APPLICATION NO.	FILING DATE	FIRST NAMED INVENTOR	ATTORNEY DOCKET NO.	CONFIRMATION NO.
10/579,877	05/18/2006	Thomas Dunker	DUNKER ET AL-2 PCT	3786
25889	7590	04/30/2009		
COLLARD & ROE, P.C. 1077 NORTHERN BOULEVARD ROSLYN, NY 11576			EXAMINER MERENE, JAN CHRISTOP L	
			ART UNIT	PAPER NUMBER
			3733	
			MAIL DATE	DELIVERY MODE
			04/30/2009	PAPER

Office Action Summary	Application No. 10/579,877	Applicant(s) DUNKER ET AL.	
	Examiner JAN CHRISTOPHER MERENE	Art Unit 3733

DETAILED ACTION

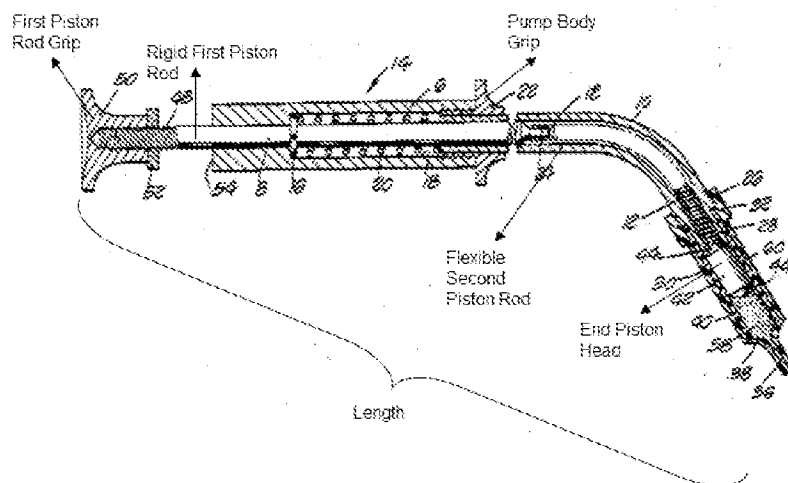
Regarding **Claim 15**, Schmitz discloses an injection pump for application of highly viscous media that have to be applied with pressure during percutaneous vertebroplasty comprising:

- (a) a pump body having a pump body proximal end, a pump body distal end, and a pump body length (as seen in Fig below);
- (b) a pump body grip fastened at said pump body proximal end (as seen in Fig below); and

(c) a piston system comprising a rigid first piston rod having a first piston rod proximal end and a first piston rod distal end, a flexible second piston rod connected to said first piston rod at said first piston rod distal end and having a second piston rod distal end, a first piston rod grip connected to said first piston rod at said first piston rod proximal end, and an end piston head at the second piston rod distal end for taking up bone cement; wherein said end piston head is movable along the pump body length between the pump body distal end and the pump body proximal end (as seen in Fig below where there is a first rigid piston rod connected to a flexible second piston rod and an end piston head moveable along the length).

Regarding **Claim 4**, Schmitz discloses the pump body has a rigidly bent shape (as seen in Fig above and see Col 2 lines 42-44).

Regarding **Claim 5**, Schmitz discloses the flexible second piston rod conforms to the rigidly bent shape of the pump body (as seen in Fig above and Col 2 lines 39-41 where the second piston rod is flexible and can conform to the bent shape).

Regarding **Claim 14**, Schmitz discloses the pump body is arranged at the pump body grip and is firmly rotatable and replaceable (as seen in Fig above in Claim 15 where it is rotatable and replaceable if one chooses to do so).

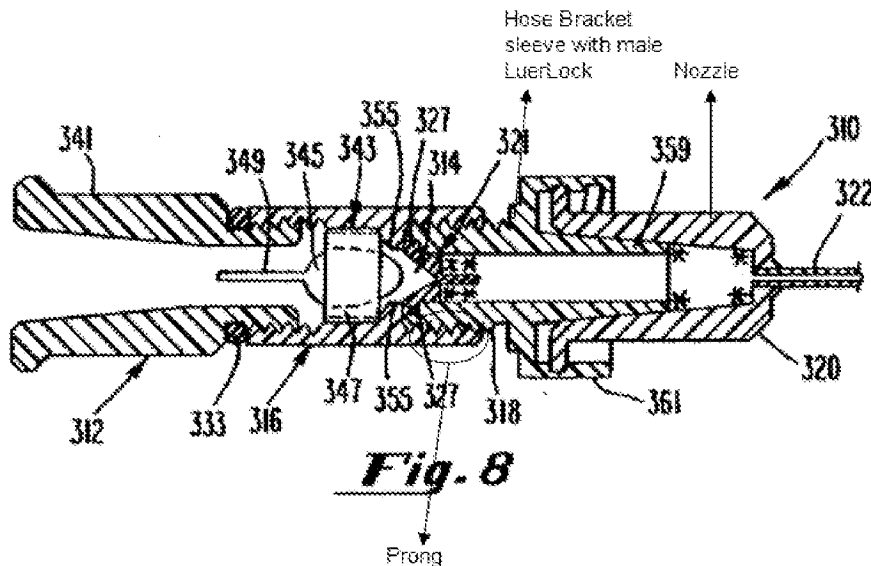
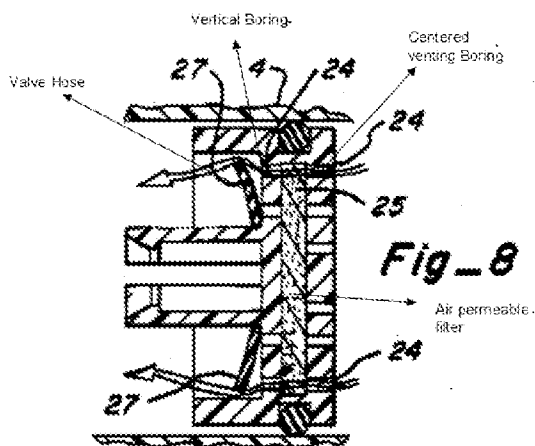
However, Century discloses disclose a hose bracket sleeve with an attached rotatable male LuerLock at the distal end of the pump body, wherein a nozzle is screwed to the rotatable male LuerLock to take up highly viscous media from a respective vessel which nozzle can be unscrewed after absorption of such highly viscous media, wherein the male LuerLock is fitted with a prong to fasten the pump body by radially pressure-forcing the pump body into place (see figs below and Col 10

lines 59-65, Col 11 lines 4-24, which teaches a standard male LuerLock to connect with a nozzle, where the LuerLock is attached to the body and is rotatable with prongs that help keep the LuerLock in place, which also exerts force on the body).

It would have been obvious to one having ordinary skill in the art at the time the invention was made to modify the LuerLock connection of the body with the nozzle of Shmitz et al with the rotatable male LuerLock connection and prongs of Century (as discussed in the previous paragraph) because it applies a known technique to a known device ready for improvement to yield predictable results of fastening a nozzle against an injection device, (see figs below and Col 10 lines 59-65, Col 11 lines 4-24).

Furthermore, the rotatable male LuerLock with prongs fitted to a complimentary nozzle as taught by Century is also a simple substitution of known element for another to obtain predictable results of fastening a nozzle against an injection device (see above).
